CSP STANDARD

FAIRLEAD, TUBE, SUPPORT

CSP 359

(-1) AS DRAWN

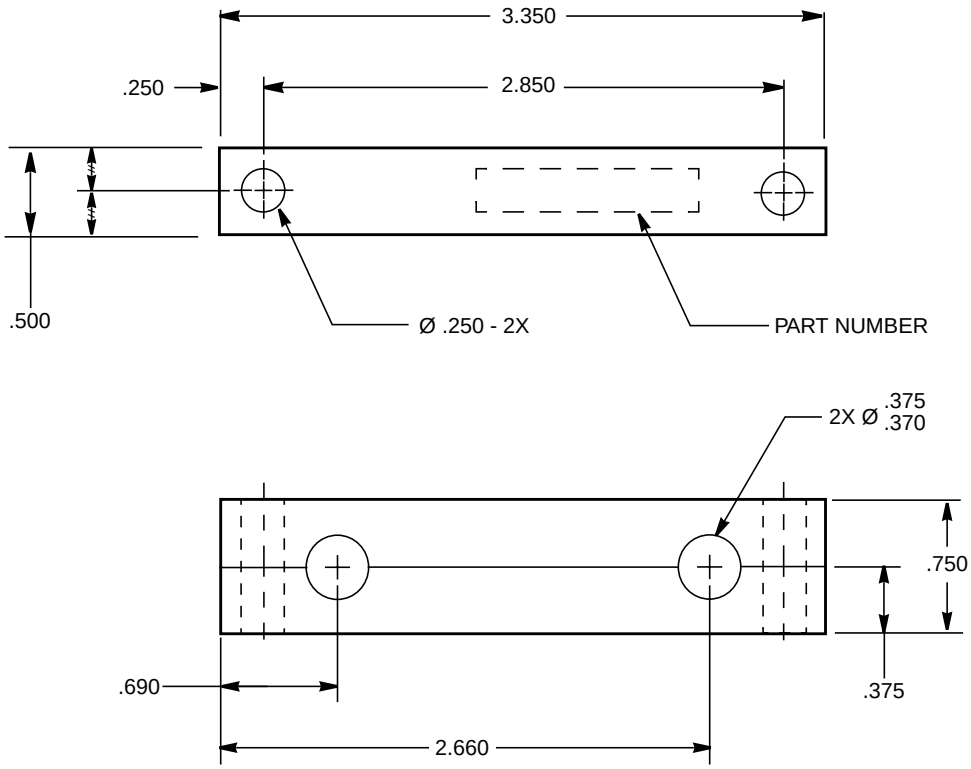
Ⓒ REVISED MATERIAL WAS "ETHYLENE PROPYLENE RUBBER PER AMS3248 _ SHORE 'A' 55-65"

Ⓒ 1. MATERIAL: ACRYLONITRILE BUTADIENE RUBBER PER AMS3215 OR NITRILE-BUTADIENE RUBBER PER AMS3224 SHORE 'A' 65-75
